VALUE ENGINEERING REPORT

Florida Department of Transportation

SR 994/SW 200th Street/Quail Roost Drive PD&E Study

Value Engineering Study Report

CONSTRUCTABILITY SKETCH
 STATE ROAD No. 994/Quail Roost Drive
 FINANCIAL PROJECT IDs 429341-3-52-01 and 429341-6-52-01

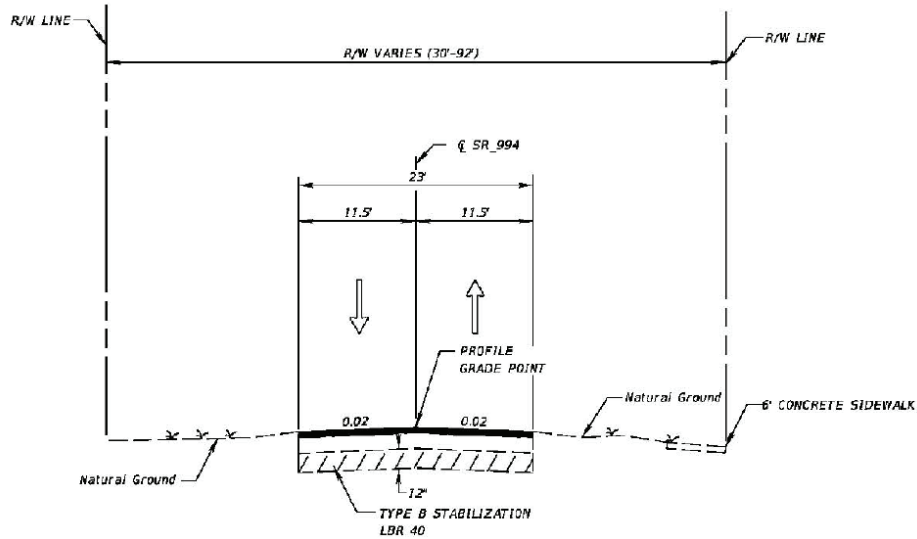
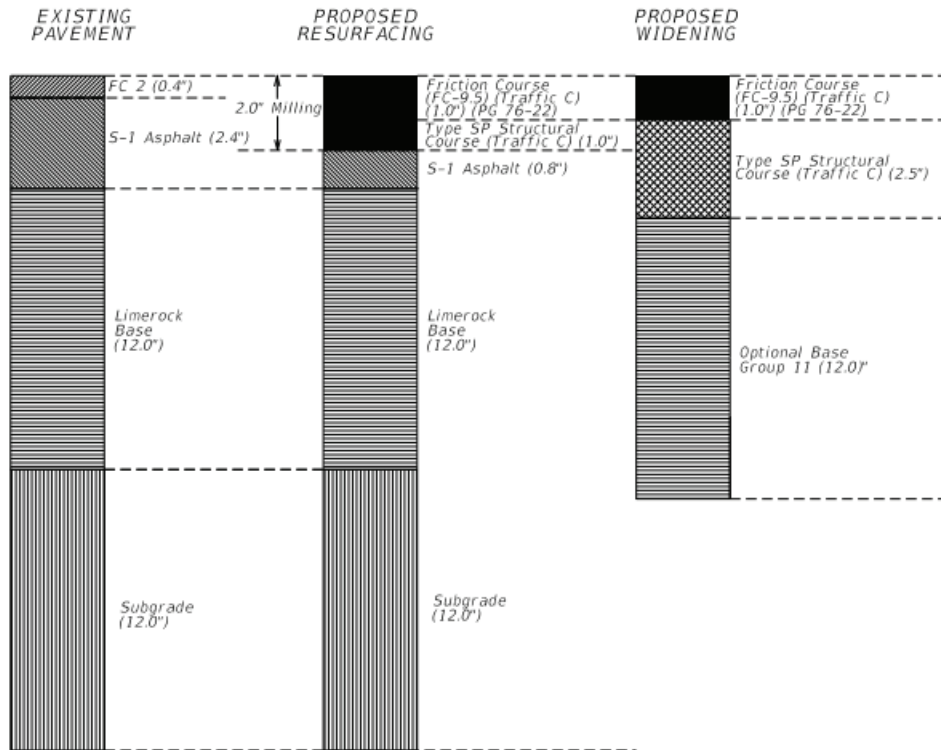
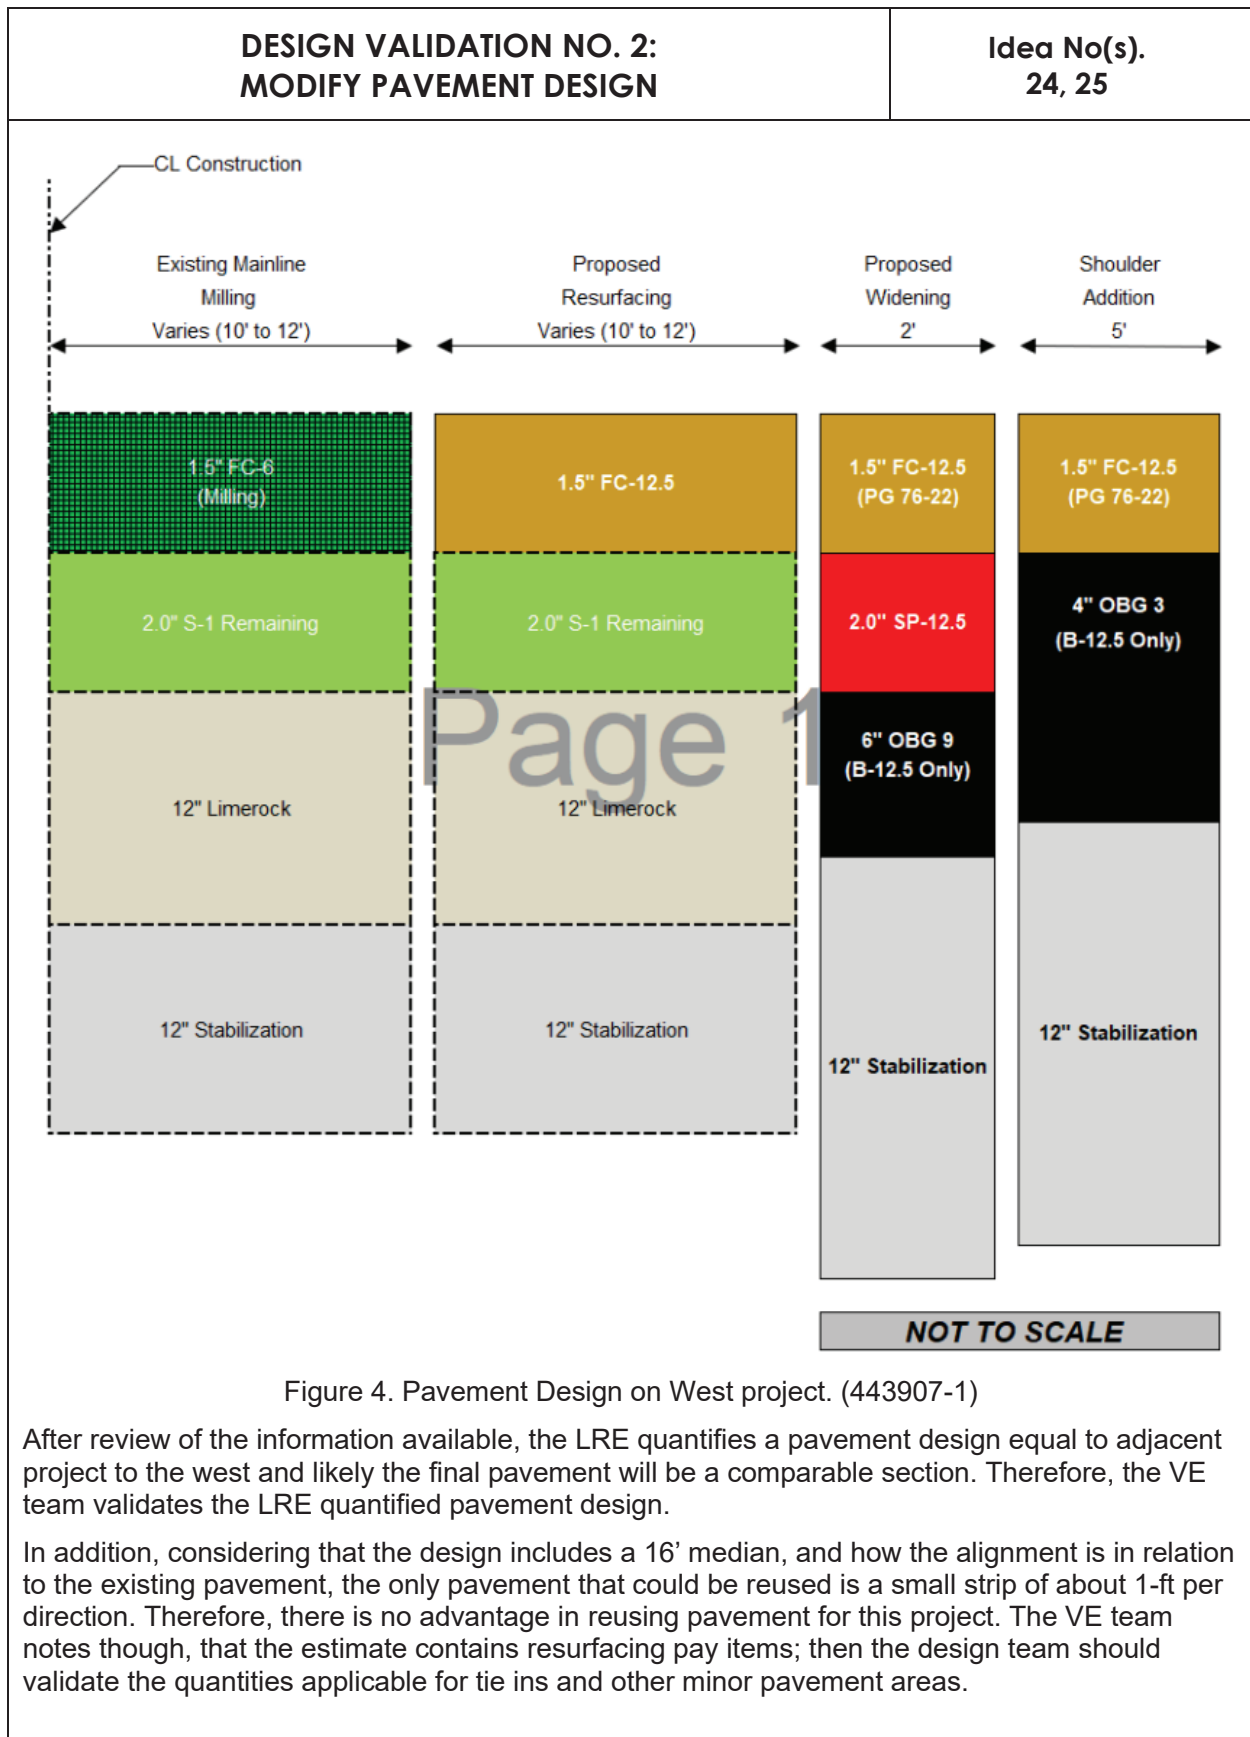
The VE team reviewed the typical sections (Existing & Proposed) shown below in Figure 1 & Figure 2 respectively.

After review of the information available, the LRE quantifies a pavement design equal to adjacent project to the west and likely the final pavement will be a comparable section. Therefore, the VE team validates the LRE quantified pavement design.

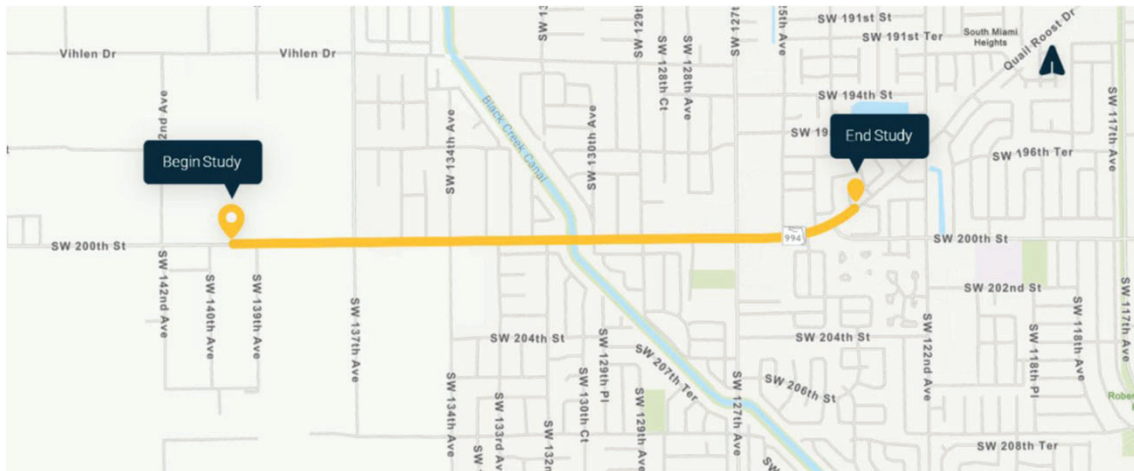
DESIGN VALIDATION NO. 3: REALIGN ROADWAY TO REDUCE ROW	Idea No(s). 1, 48
Discussion/Sketches/Photos/Calculations	
<p>Technical Discussion/Sketches</p> <p>The current baseline concept design aligns the roadway through the center of the corridor and impacts parcels on both sides. The recommended concept is to realign the roadway to only impact parcels on one side of the corridor and avoid parcels that will be more expensive.</p> <p>Reviewing the CADD plans and attempting to shift the alignment it was clear that the existing usable space was maximized and that ROW acquisition was only necessary in areas where actually needed. This analysis was done assuming a typical section width of 97-ft .</p> <p>However, if the preferred alternative were to shrink the typical section width in anyway, the VE team recommends that the roadway and potential impacts be reanalyzed to determine if any existing structures or historical wall / buildings can be avoided. Currently most ROW impacts appear to be minimal.</p> <p>Overall, the VE team's analysis reinforces the current recommendation stating that the current layout is minimizing the amount of ROW required for the baseline design with the given typical section.</p> <p>Assumptions/Calculations</p> <p>No calculations needed as recommendation validates baseline.</p>
